Access Compliance Report

Public Rights-of-Way

Intersection ID: 24123	Main Street: SOUTH_BRIDGE_CR	Cross Street: SOUTH_POINT_BV	Location: SW
ADA ID: 947DDF94435E	Ramp Type: Perp	Initial Pass/Fail: Fail	Overall Compliance: No
Severity Score: 1.25			
Codes/Mitigation Info/Possible Solution		Field Measurements/Component Compliance

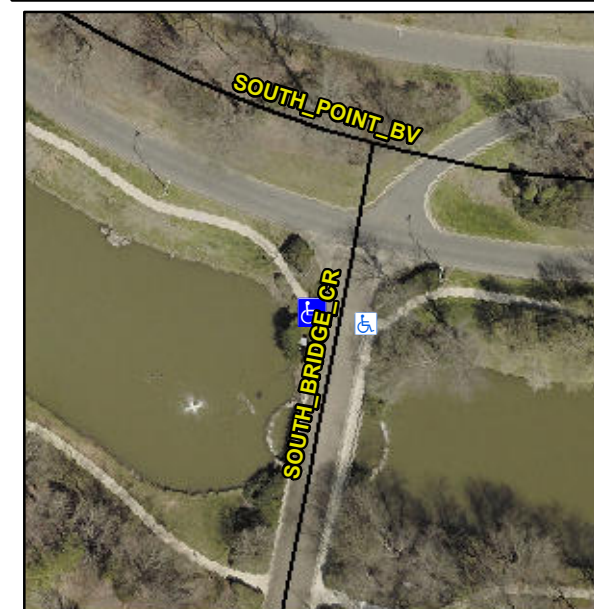
Not Found, R304.5.3

Compliance	Description	Data	Compliance	Description	Data
N/A	Ramp Length (in)	50.0	Yes	Ramp Slope (%)	6.3
Yes	Ramp Width (in)	48.0	No	Ramp XSlope (%)	2.3
N/A	Flare Type LT	N/A	N/A	Flare Type RT	N/A
N/A	Flare Slope LT (%)	N/A	N/A	Flare Slope RT (%)	N/A
N/A	Flare Traversable LT?	N/A	N/A	Flare Traversable RT?	N/A
N/A	Landing Length (in)	N/A	N/A	DWS Provided?	N/A
N/A	Landing Width (in)	N/A	N/A	DWS Contrast?	N/A
N/A	Landing Slope (%)	N/A	N/A	DWS Length (in)	N/A
N/A	Landing X Slope (%)	N/A	N/A	DWS Full Width?	N/A
N/A	Landing Curb? (Y/N)	N/A	N/A	DWS Offset (in)	N/A
N/A	Shared Landing?	N/A			
N/A	Gutter Ponding?	N/A	N/A	Gutter Slope (%)	N/A
N/A	Gutter Lip Ht (in)	N/A	N/A	Gutter X Slope (%)	N/A
N/A	Painted X Walk1?	No	N/A	Painted X Walk2?	N/A
	X Walk 1 Direction	To E		X Walk 2 Direction	N/A
N/A	X Walk 1 Width (in)	N/A	N/A	X Walk 2 Width (in)	N/A
	X Walk 1 Slope (%)	2.2		X Walk 2 Slope (%)	N/A
	X Walk 1 X Slope (%)	2.6		X Walk 2 X Slope (%)	N/A

Remove & Replace Entire Ramp.
